PARTS & SERVICE NEWS

REF NO. AA03155B

SUBJECT: REWORK PROCEDURE TO IMPROVE DURABILITY OF FRONT AND REAR SUSPENSION

PURPOSE: To introduce rework procedure to improve durability of the front and rear suspension on dump trucks.

(2) Rear suspension

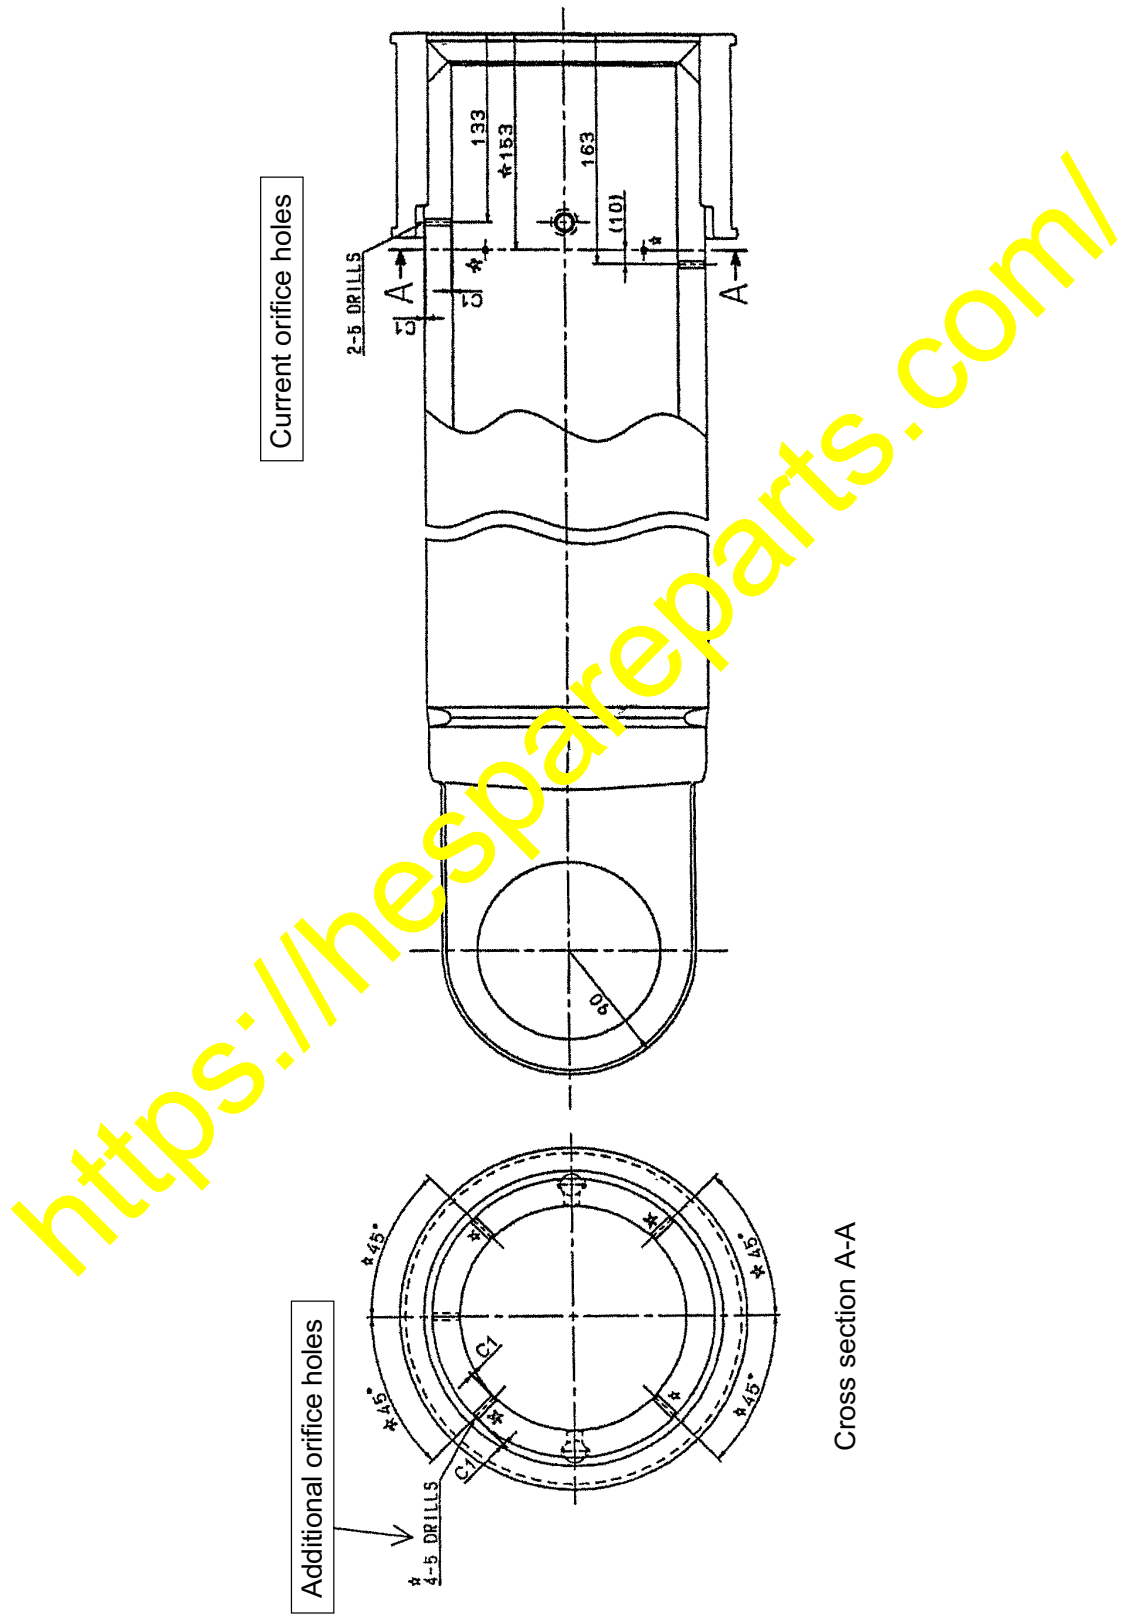
Improved suspension	Current suspension																												
Contents of the modification	<ul style="list-style-type: none"> The material of the bushing has been changed.(DD ← DU) A buffer ring has been added. The flange has been changed. The length of the flange mounting bolt has been changed. Number of orifice holes in the rod are increased by additional working. (2 places → 6 places) The decal plate has been changed. 																													
Structure																														
Part No.	<table border="0"> <tr><td>12. Buffer ring</td><td>707-51-20640</td></tr> <tr><td>13. Bushing</td><td>561-50-6B330</td></tr> <tr><td>14. Flange</td><td>561-50-6B190</td></tr> <tr><td>15. Spacer</td><td>561-50-6B390</td></tr> <tr><td>16. Bolt</td><td>01011-81420</td></tr> <tr><td>17. O-ring</td><td>07000-15240</td></tr> <tr><td>18. Backup ring</td><td>07001-05240</td></tr> <tr><td>19. Rod</td><td>561-50-6T131</td></tr> </table>	12. Buffer ring	707-51-20640	13. Bushing	561-50-6B330	14. Flange	561-50-6B190	15. Spacer	561-50-6B390	16. Bolt	01011-81420	17. O-ring	07000-15240	18. Backup ring	07001-05240	19. Rod	561-50-6T131	<table border="0"> <tr><td>13. Bushing</td><td>568-50-11330</td></tr> <tr><td>14. Flange</td><td>561-50-6A150</td></tr> <tr><td>16. Bolt</td><td>01011-81400</td></tr> <tr><td>17. O-ring</td><td>07000-15240</td></tr> <tr><td>18. Backup ring</td><td>07001-05240</td></tr> <tr><td>19. Rod</td><td>561-50-6B130</td></tr> </table>	13. Bushing	568-50-11330	14. Flange	561-50-6A150	16. Bolt	01011-81400	17. O-ring	07000-15240	18. Backup ring	07001-05240	19. Rod	561-50-6B130

* No. 17 and 18 parts are consumable parts.

* Regarding the No. 19 part, current part can be reused after carrying out additional working.

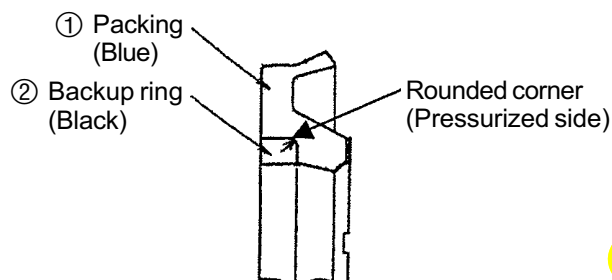
- (1) Carry out the disassembly and reassembly work referring to the Shop Manual when replacing the parts with the improved ones.
- (2) Add the orifice holes with a ϕ 5.0 drill at the four places marked ☆ in the drawing below of the disassembled rod (561-50-6B130).

- (3) After the additional working to add the orifice holes on the rod, remove burrs completely from the inside and outside surfaces. Also, before reassembling the rod, remove cutting chips which have entered into the piston section of the rod completely by air blow.
- (4) Since the buffer ring which is to be added newly is made of two sections of ① packing section (being colored blue) and ② backup ring section (being colored black), install the rounded corner side of the ② backup ring section into the ① packing section.

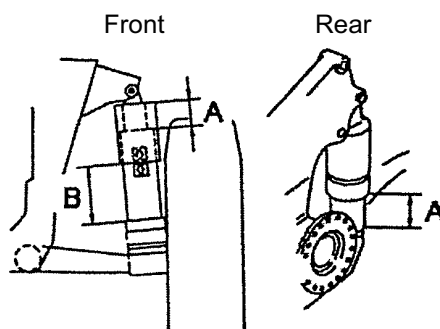
- (5) When adjusting the mounted length of the suspension cylinder after this modification work, carry out the adjustment work referring to the "Modified value" of the adjustment standard indicated in the Table below.

Item			Vehicle model	HL785/330M	HD985
Mounted length	Front	A	Current value	262 ± 10	262 ± 10
			Modified value	246 ± 10	246 ± 10
		B	Current value	484 ± 10	484 ± 10
			Modified value	484 ± 10	484 ± 10
	Rear	A	Current value	240 ± 10	250 ± 10
			Modified value	220 ± 10	230 ± 10

Remain the same.

(Note) When charging the nitrogen (N₂) gas, since the gas will be dissolved into the new oil and the dimension "A" will be shortened, charge it somewhat in excess (by 20 - 30 mm).

After operating the vehicle for 24 to 48 hours, inspect the cylinders for gas leakage, oil leakage and check the dimension "A". When necessary, carry out re-adjustment of the dimension "A".

FIGURE 1. BUSHING INSTALLATION TOOL (561-99-79220)
 Material Specification: ASTM A36/A36M

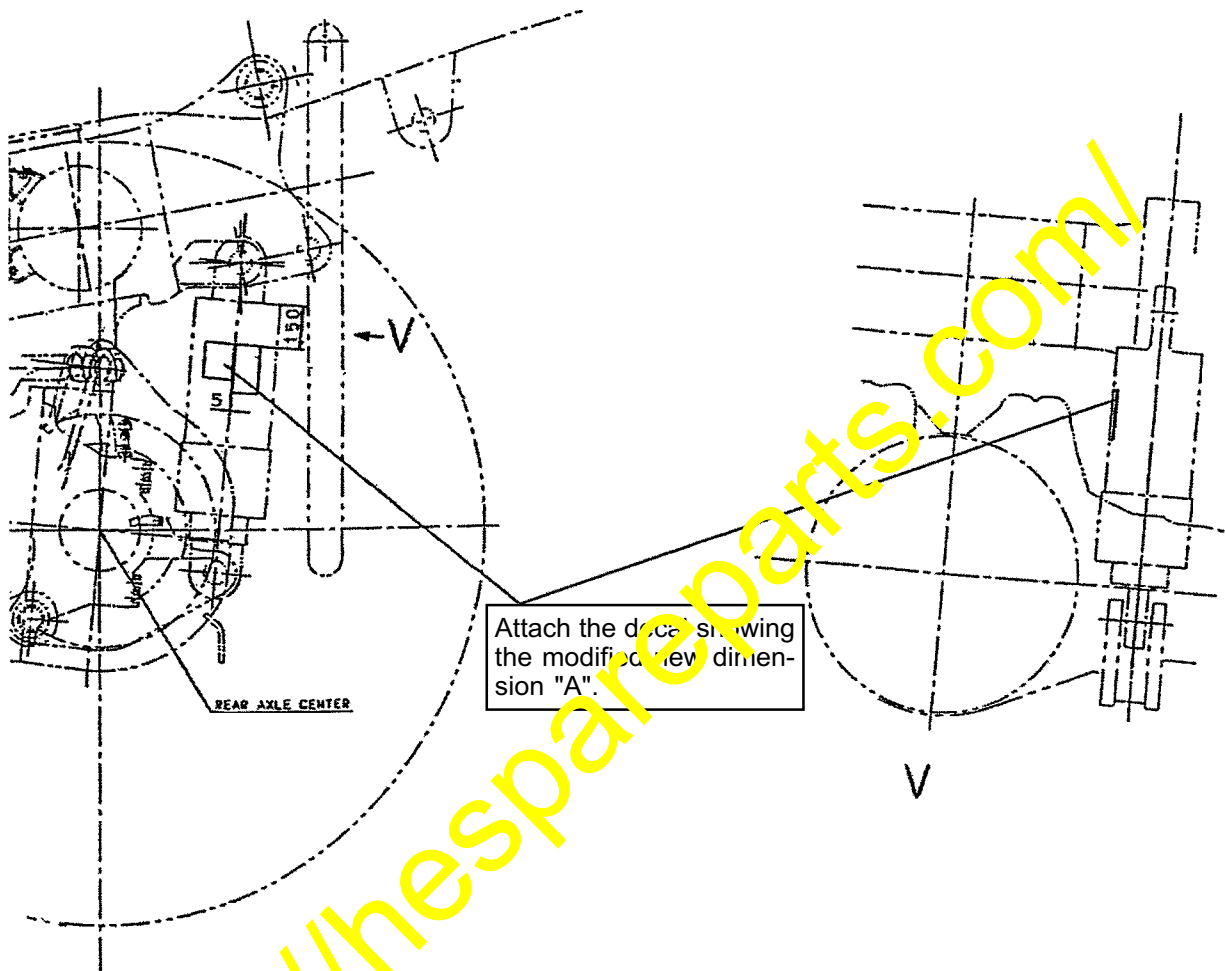
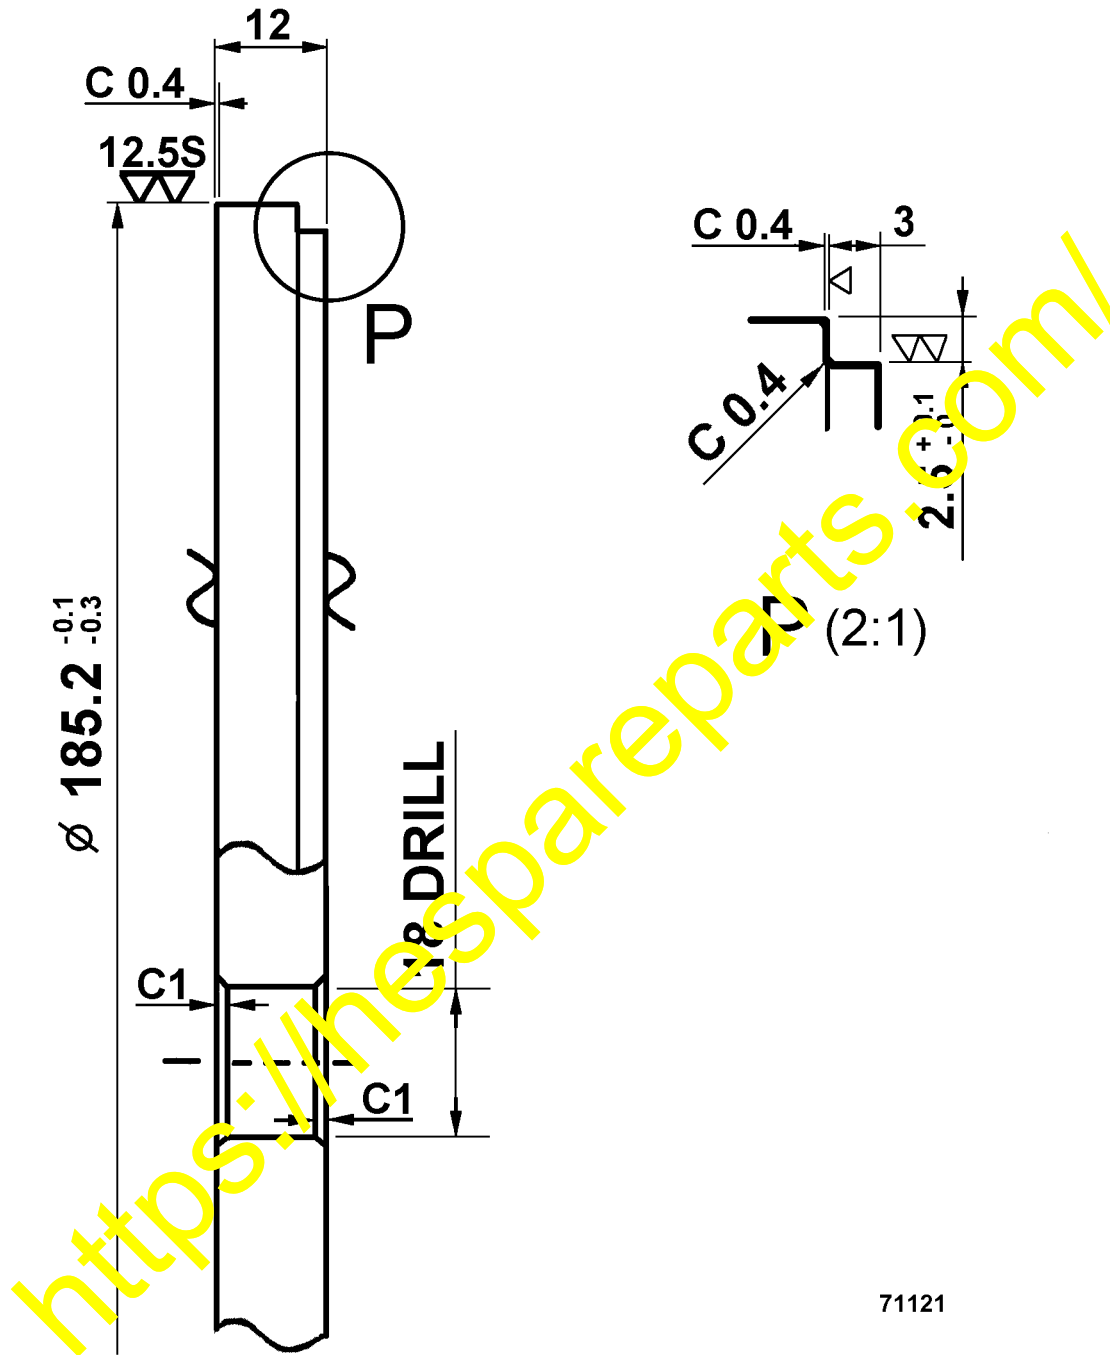
NOTE: A special tool is required to install the new bushing inside the front suspension. See page 9 (Figure 1) for details on how to fabricate the tool locally.
